AMENDED APPLICATION

PRESENTED TO THE
BOARD OF ZONING ADJUSTMENTS
FOR THE
GOVERNMENT OF THE
DISTRICT
OF
COLUMBIA

BZA APPLICATION NO. 17315

1220 - 1236 4th Floor Plan Adjustments

Ridge Street Elevation

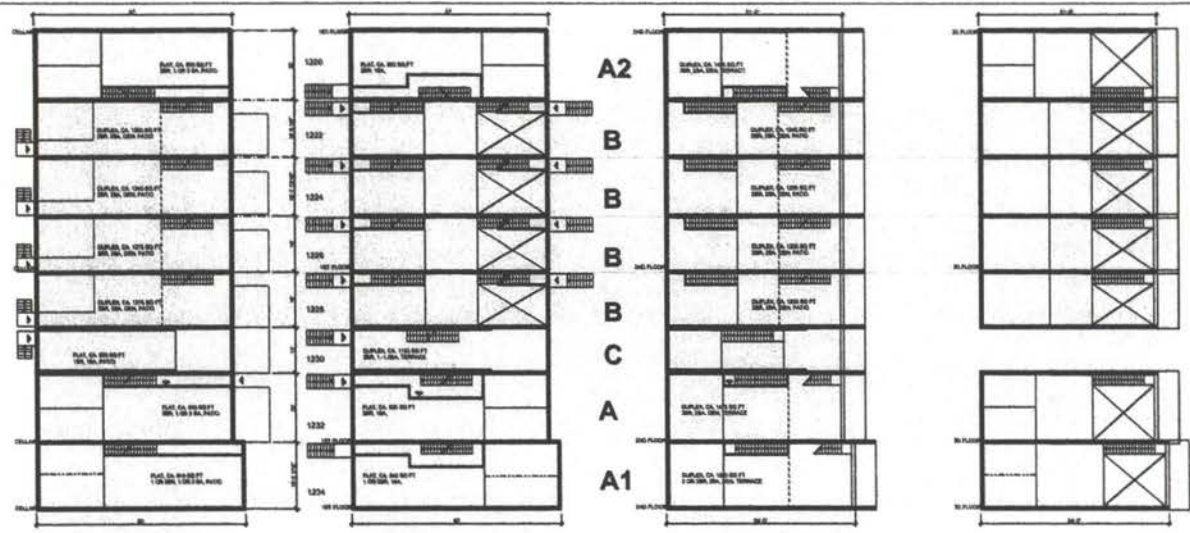
Finally, the rear elevations will obviously require further development, as will the Ridge Street elevation of the corner building (its fenestration and the treatment of the parapet need some work²). In addition, the four one-story bays on the front elevation should have a more substantial cornice—more in keeping with Italianate houses of the 1850s to 1870s—instead of rails or balustrades on top. A deck and railing on such a rowhouse bay is an unusual and probably demonstrably useless feature. Without the deck, the fenestration of those facades could be more regular and in scale.

3. Side and Rear facades. Residents did express concern about the Ridge Street side of 1220 4th Street. They felt that the flat appearance was lacking in detail and did not blend with the surrounding architecture. Members of the community also pointed out that a significant

Looking Northwest from the corner of
4th Street and Ridge Street, NW

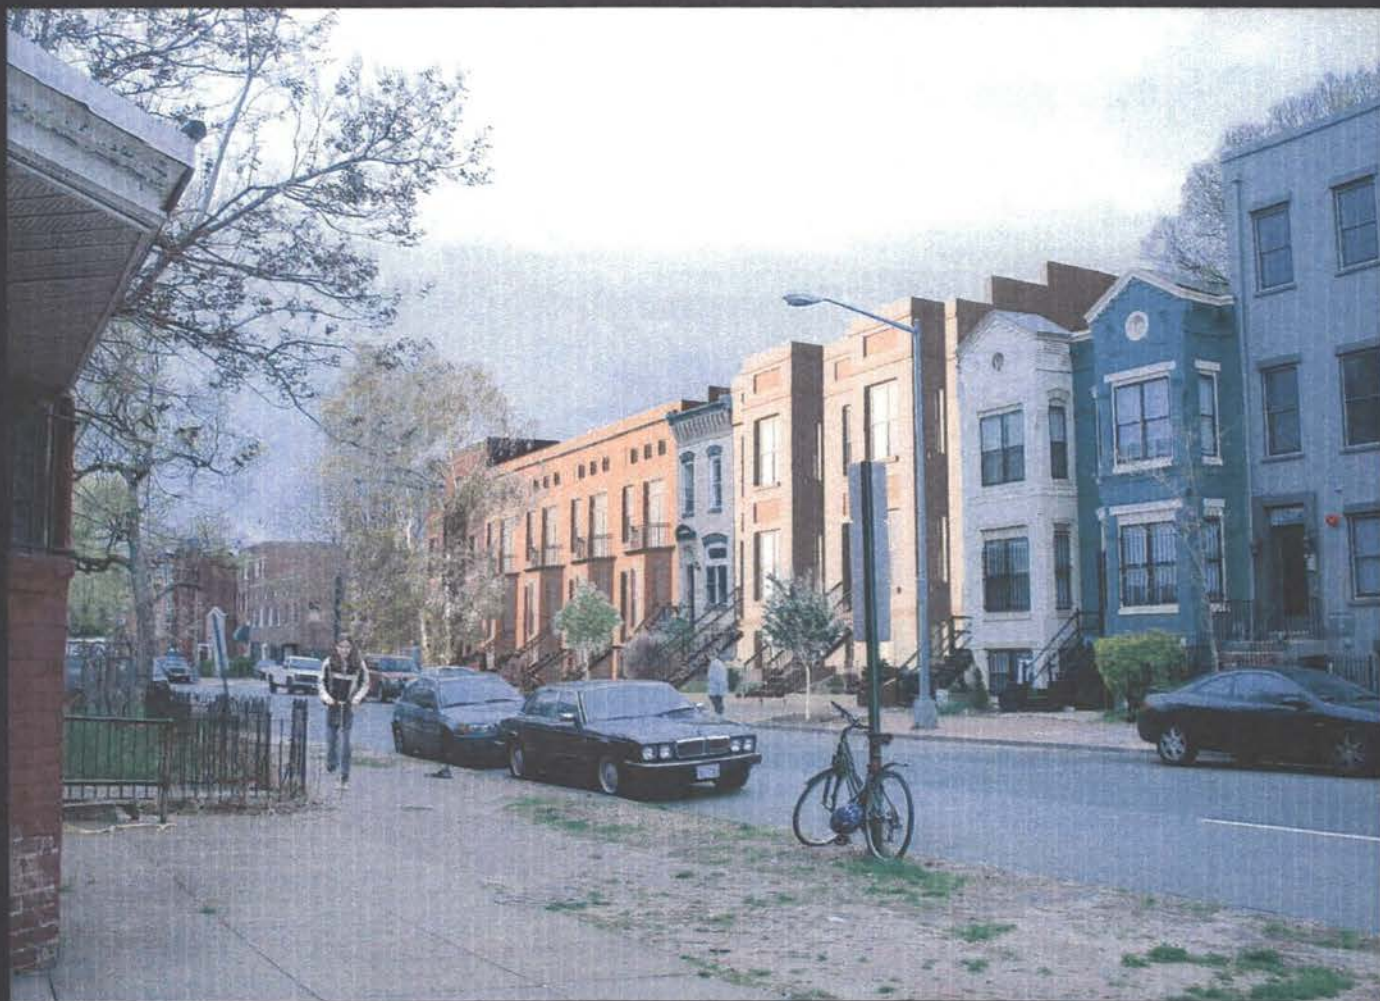
The proposed buildings would each stand three stories, but with the top story set back either fourteen feet or eighteen feet—with the exception of the corner building, #1220, which would have a full-depth third floor—in order to screen the setback story. The setbacks would consist of very low-pitched roofs in front, pierced with skylights, that presumably would not be visible from the street over the proposed parapets. The houses would sit on rather elevated basements and have shallow areaways, but ones not unlike those of the adjacent historic buildings. All of the new houses would have projecting bays of one or two stories.

First, in order to screen the set-back portions, the parapets of the buildings are high, particularly on the four houses north of the corner building. Despite being drawn with particularly tall windows—the tops of the windows openings are about nine feet above the floors—the space above the second-floor windows is at least eight feet and will appear in reality as disproportionately high “foreheads,” even with devices such as cornice projections, panels or vents to break up the space visually.¹ The parapets should be lowered, but this would then expose the third floors. Indeed, any or all of the new houses could be and should be lowered a little; they generally have nine-foot floor-to-ceiling heights and the first floor of each is a full ten feet.

the staff recommends that the first five houses north of the corner of Ridge be designed as of a full three stories each, and that the two buildings at the north end of the parcel be of only two stories (the heights of the bays would be adjusted or rather switched accordingly, to two stories and one story, respectively). In addition, the staff recommends that the demolition of #1230 be limited to the rear wall (and not floor and roof structure unless absolutely necessary); that no portions of new buildings be built on top of or over the side walls of #1230; that any one-story bays not hold decks; and that the rear elevations and the side elevation of #1220 continue to be developed.
